490-500 Burwood
Highway, Vermont
South / **Planning
Scheme Amendment
C230whse**

Date of report
20 January 2023

- (3) In preparing my evidence I have assessed the exhibited Amendment documentation and in particular, the proposed Design and Development Overlay - Schedule 6 '490-500 BURWOOD HIGHWAY, VERMONT SOUTH (FORMER AUSTRALIAN ROAD AND RESEARCH BOARD SITE)' (DDO6)

Figure 5. Figure 1 - Concept Plan with annotations added

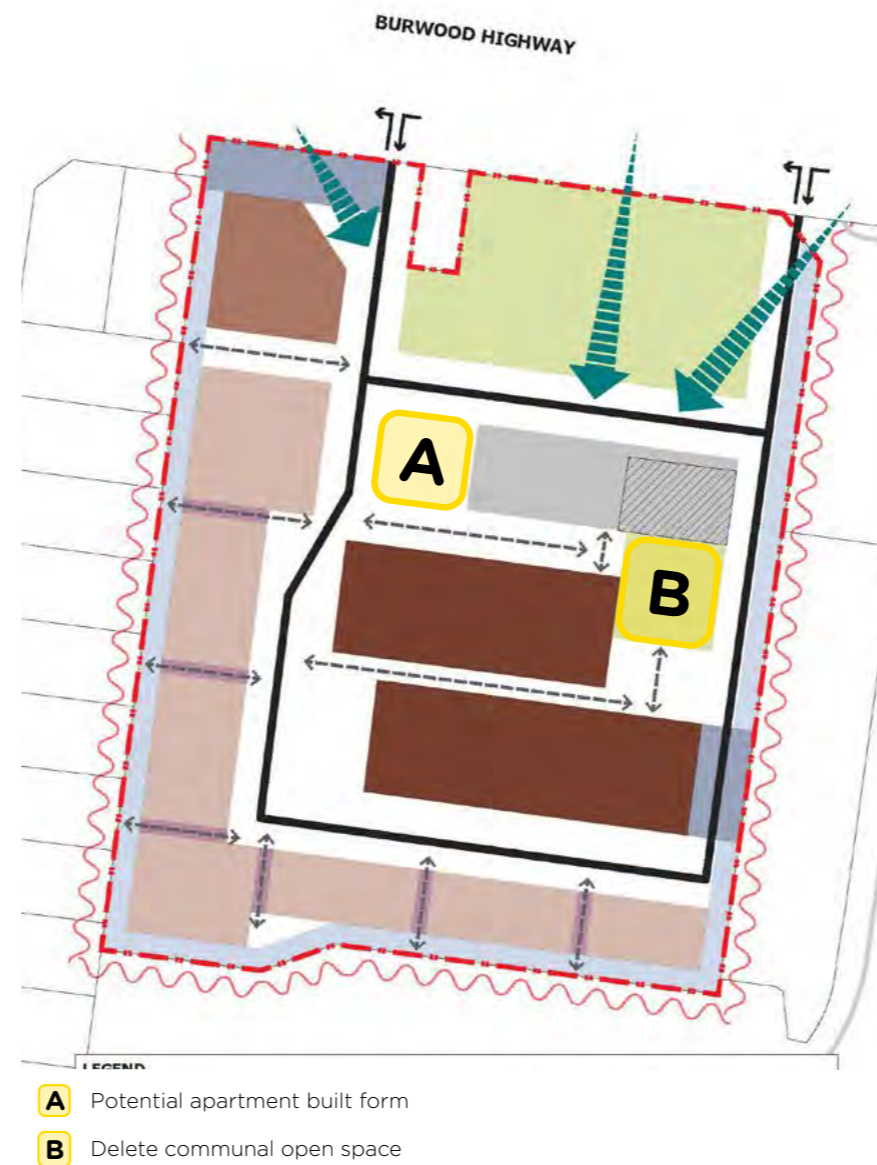
- (40) From a review of the heritage significance of the place and the CMP consider the direction applied through the proposed DDO6 to be generally responsive to protecting the heritage values of the Site.
- (41) However, there are two elements detailed on the Concept Plan within DDO6 that appear to be unjustified based on the assessment provided in the CMP. These are highlighted at Figure 5.

- (42) The first element is the identification of communal open space directly south of the eastern end of the Administration Building. This appears to align with an existing courtyard which includes a brick barbeque and is edged by Research Wing R2 to the south and R1 to the west.

- (44) In my opinion, I do not think it necessary to identify the specific location of communal open space on the Concept Plan. Furthermore, Standard D7 of Clause 58.03-2 requires the provision of communal open space that meets the recreation and amenity needs of residents, and the proposed SLO10 seeks to retain and enhance valued features of the landscape character of the Site.

- (47) The second element is the identification of building envelopes on the Concept Plan and the level of specificity proposed, which is likely to create inflexibility to a varied massing layout, restricting innovation and good design outcomes. I discuss the application of building envelopes more broadly from an urban design perspective in Section 3.3.

- (48) From an urban design perspective and from reviewing the CMP, it is unclear why no built form is directed to the western end of the Administration Building.

- (51) However, I assess the requirement for no built form west of the Administration building to be overly restrictive. I consider some built form could be achieved in this space while protecting key view lines from Burwood Highway and

- (52) Based on the CMP and key areas of heritage significance on the Site I make the following recommendations:
 - Revise Figure 1 – Concept Plan as follows:
 - Remove ‘communal open space’ identified to the south of the Administration Building.
 - Replace building envelopes with areas of building height and typology (refer to Section 3.3). With this change, add an area of opportunity for apartment built form to the west of the Administration Building.
 - Please note: as the above recommendations are subject to heritage advice they have not been incorporated on the Preferred Concept Plan.

Figure 6. Figure 1 - Concept Plan (DDO6)

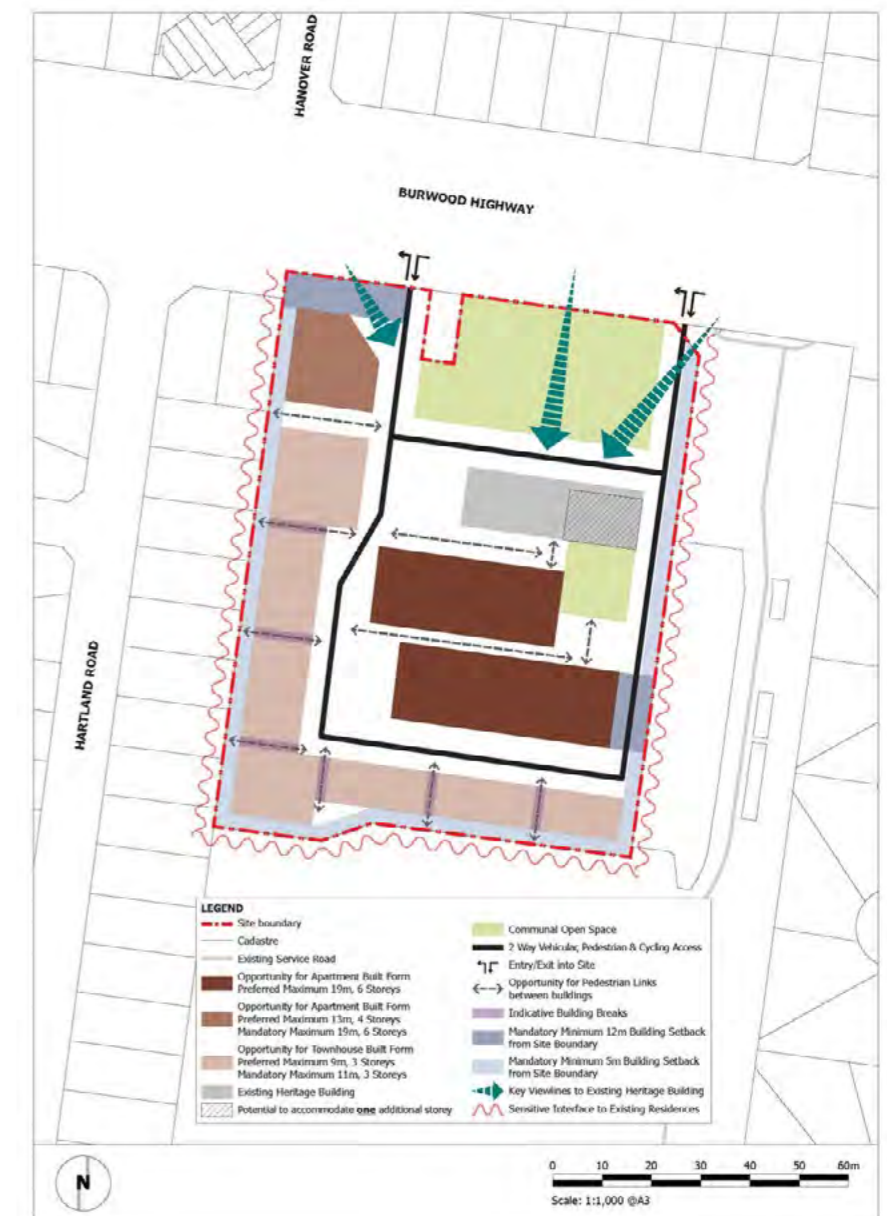
(67) It is noted that both the proposed DDO11 and DDO6 propose a mandatory maximum height of 19m (6 storeys). Based on an absolute minimum floor-to-floor height of 3.1m, 19m does not allow space for higher floor-to-floor heights to be introduced over 6 storeys. Based on this, I recommend

(70) Though the application of building envelopes to the Concept Plan will assist in creating a degree of certainty in relation to the eventual development outcome, they restrict the ability to develop a varied massing layout on the Site. I also consider the proposed layout of the apartment envelopes to be a substandard outcome from an urban design perspective.

(71) Firstly, the length of the apartment envelopes has the potential to appear bulky and overwhelming when viewed from the Victorian Grange Aged Care facility to the south. Particularly as the northern edge of the Victorian Grange site sits approximately 1 to 1.5m lower relative to the proposed location of the southern apartment building.

(90) However, in reviewing the Concept Plan I find the placement of the pedestrian links to be haphazard. Particularly the pedestrian links proposed through the townhouses.

(94) Based on the above, as shown at Figure 9, I recommend the deleting the pedestrian link annotations from the Concept Plan.

any reference to 6 storey building height is revised to 20m, which will allow for higher floor-to-floors without the ability to squeeze an extra floor.

(75) In relation to building heights and configuration, I recommend the building envelopes as shown on Figure 1 - Concept Plan are replaced with areas of building height and typology as shown at Figure 9 'Preferred Concept Plan'.

Figure 9. Preferred Concept Plan (source: kinetica)

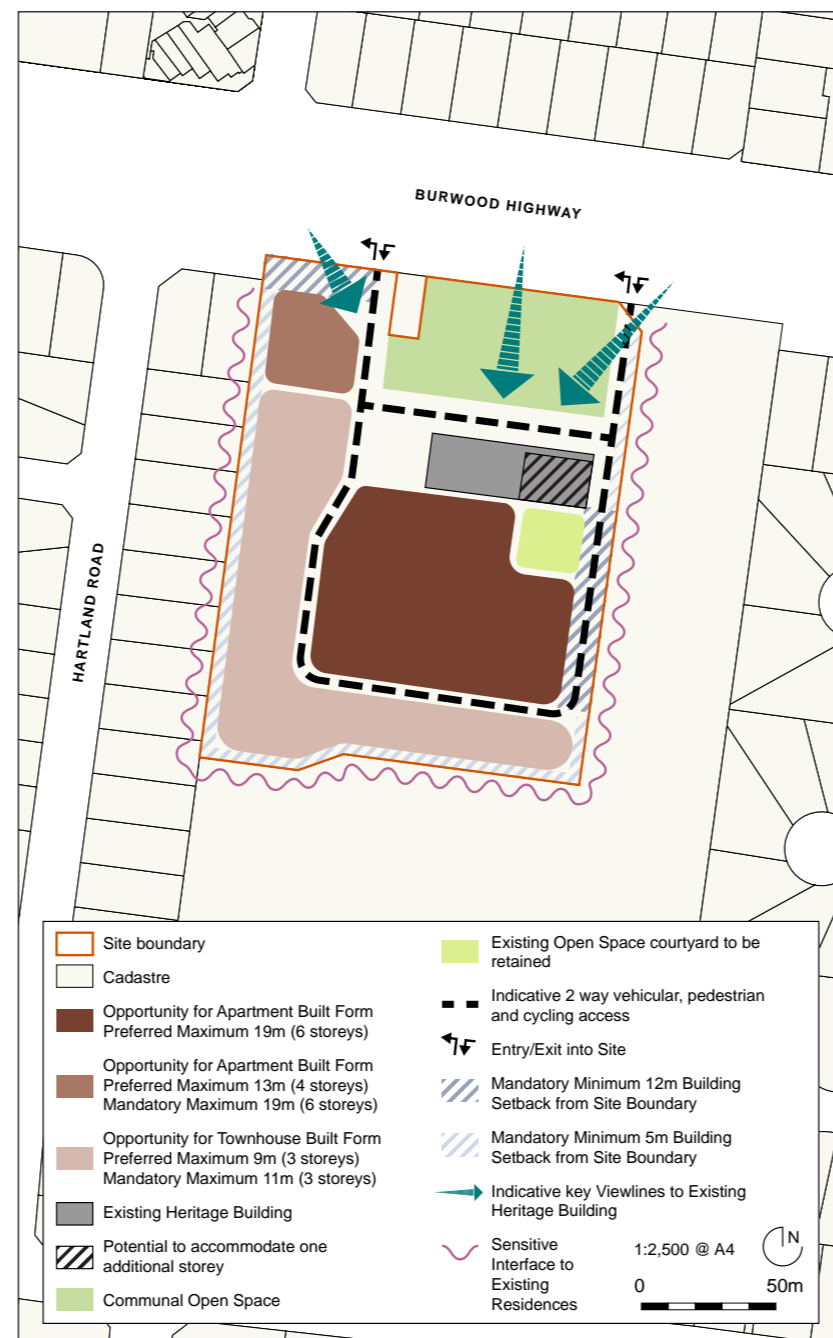
(87) I note, the Preferred Concept Plan provided at Figure 9 proposes to delete the building envelopes, replacing them with an area of 6 storeys. In response, the 12m mandatory setback is applied to the full extent of the 6-storey built form area along the eastern boundary.
